IEEE *Draft* P802.3cg/D3.0 10BASE-T1L LPI synchronization

1 MAY 2019

LPI QUIET REFRESH synchronization

Figure 146-14 – PHY Control state diagram (part a)

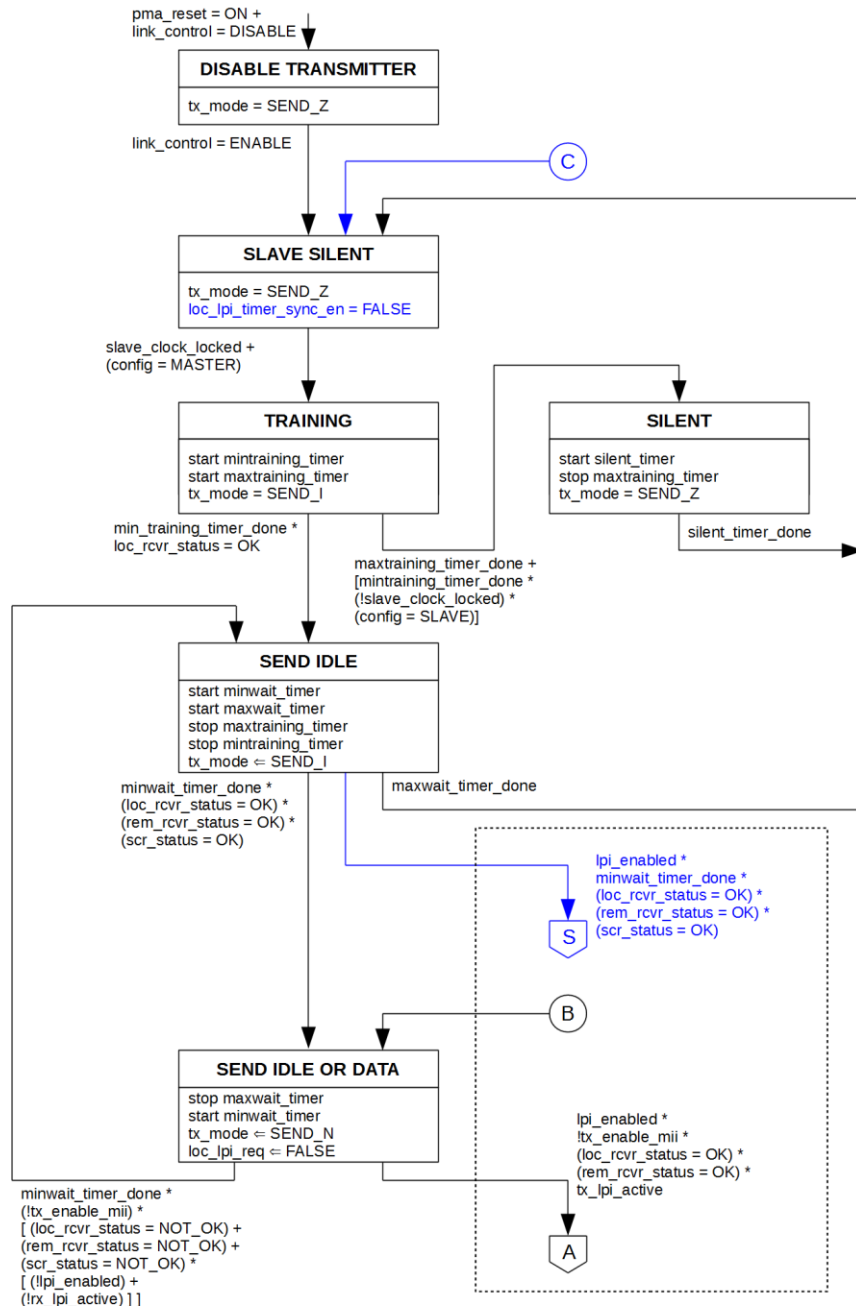
- ▶ Added entry to LPI synchronization sequence on exit from SEND IDLE state for LPI mode (labelled 'S' in diagram)
- ▶ New output from PHY Control state diagram: `loc_lpi_timer_sync_en`
 - TRUE enables local LPI synchronization timing
 - FALSE disables local LPI synchronization timing
 - Not encoded in transmit symbol stream; no new communicated parameters required

PHY Control LPI synchronization

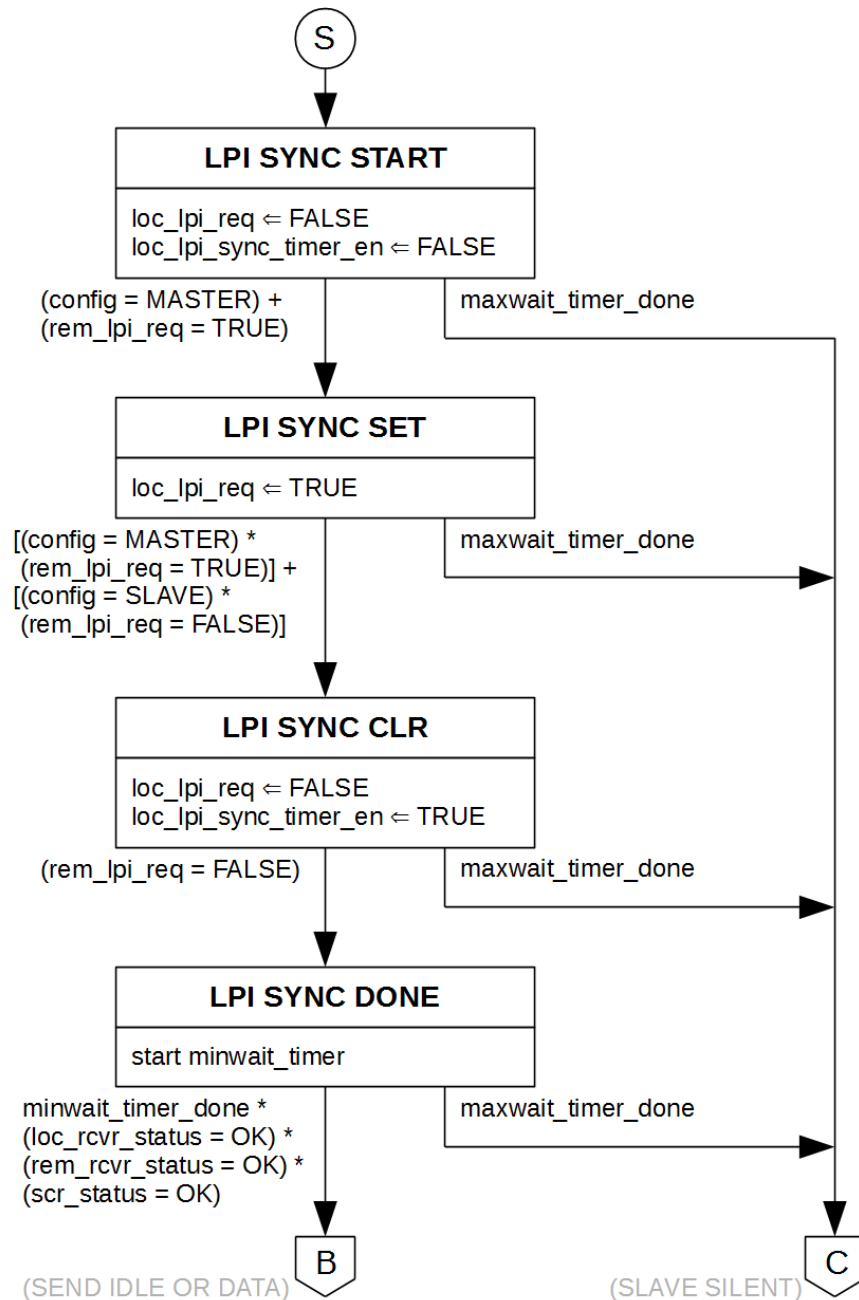
- ▶ LPI synchronization sequence is described as follows:
 - MASTER first sets `loc_lpi_req = TRUE`
 - SLAVE waits to see `rem_lpi_req = TRUE` (from MASTER), and then sets `loc_lpi_req = TRUE`
 - MASTER waits to see `rem_lpi_req = TRUE` (from SLAVE), and then sets `loc_lpi_req = FALSE`
 - MASTER also sets `loc_lpi_sync_timer_en = TRUE` at the same time
 - SLAVE waits to see `rem_lpi_req = FALSE` (from MASTER), and then sets `loc_lpi_req = FALSE`
 - SLAVE also sets `loc_lpi_sync_timer_en = TRUE` at the same time
- ▶ In both MASTER and SLAVE, transition of `loc_lpi_req` from TRUE to FALSE occurs at the same time as start of local LPI synchronization timing (`loc_lpi_sync_timer_en` transition from FALSE to TRUE).
- ▶ LPI synchronization mechanism takes place before link startup completion (PHY Control transition to SEND IDLE OR DATA).

LPI QUIET REFRESH timing state diagram

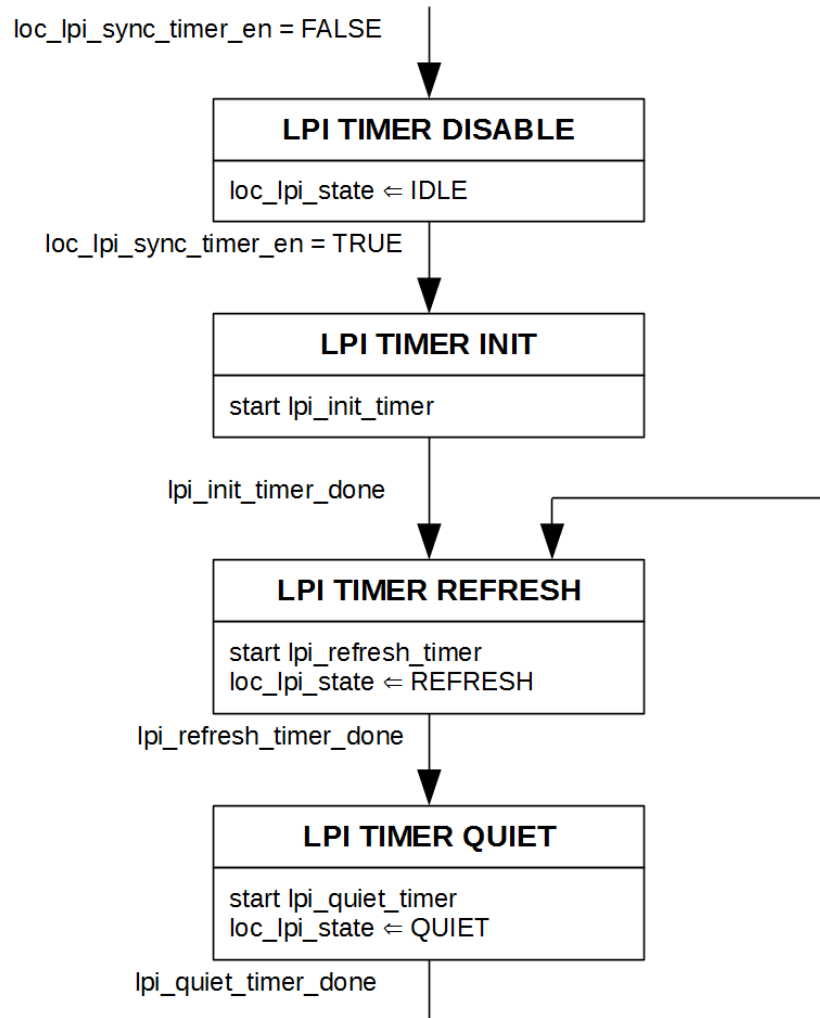
- ▶ Timing offset between MASTER and SLAVE REFRESH is effected in LPI TIMER INIT state:
 - Define `lpi_init_timer` duration differently between MASTER and SLAVE
 - MASTER `lpi_init_timer` duration 0 μ s
 - SLAVE `lpi_init_timer` duration 3000 μ s
 - This offset, i.e. 3000 μ s, should be maintained for lifetime of link
- ▶ Maintain `lpi_refresh_timer` and `lpi_quiet_timer`:
 - `lpi_refresh_timer` 250 μ s
 - `lpi_quiet_timer` 6000 μ s
- ▶ All timers here would be synchronized to symbol period (TX_TCLK). Might be defined in terms of symbol periods.
 - As SLAVE maintains timing lock with MASTER, so timing relationship between MASTER and SLAVE LPI QUIET REFRESH cycling should also remain fixed (and predictable)

PHY Control LPI sequencing

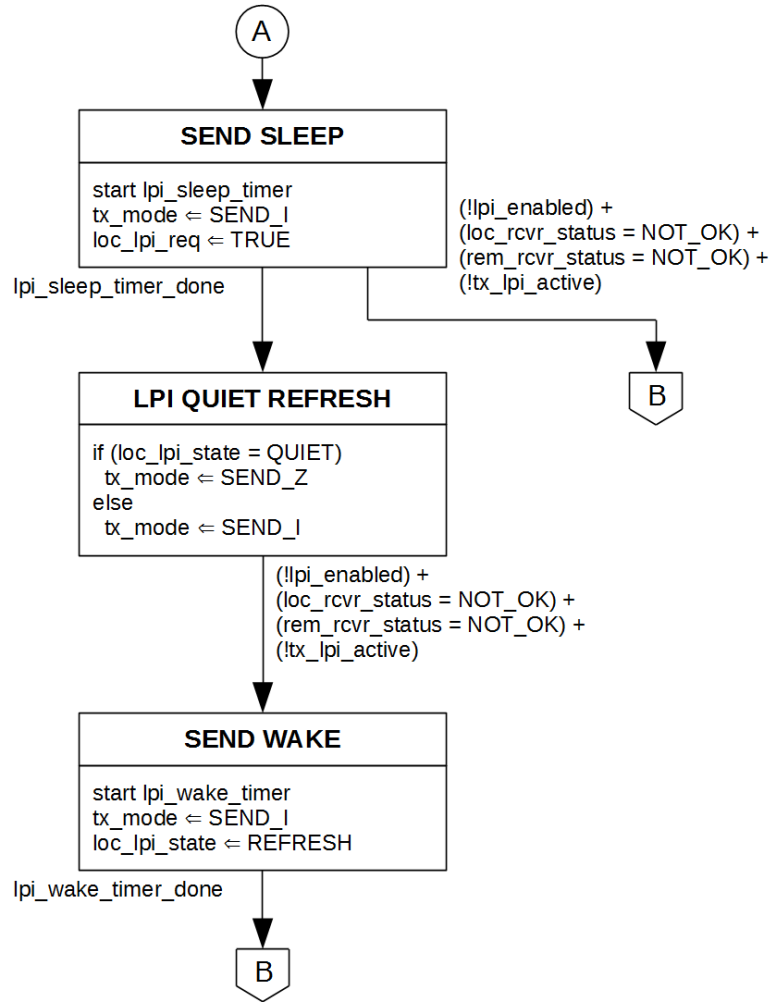
- ▶ LPI QUIET/REFRESH is set by loc_lpi_state variable, an output of the LPI QUIET REFRESH timing state diagram
- ▶ Propose to reduce lpi_sleep_timer duration
 - Currently this is set to $205 \mu\text{s} \pm 5 \mu\text{s}$
 - The reason for the relatively long duration here is to allow any ongoing adaptation tasks to complete before transmission ceases in QUIET state.
 - But, given that link partner LPI QUIET REFRESH cycling can be known with certainty, a PHY should align to this, and should never require a longer duration in SEND SLEEP.
 - Propose lpi_sleep_timer duration of $20 \mu\text{s}$, same as minwait_timer duration.
 - Might be specified in terms of transmit symbol periods.
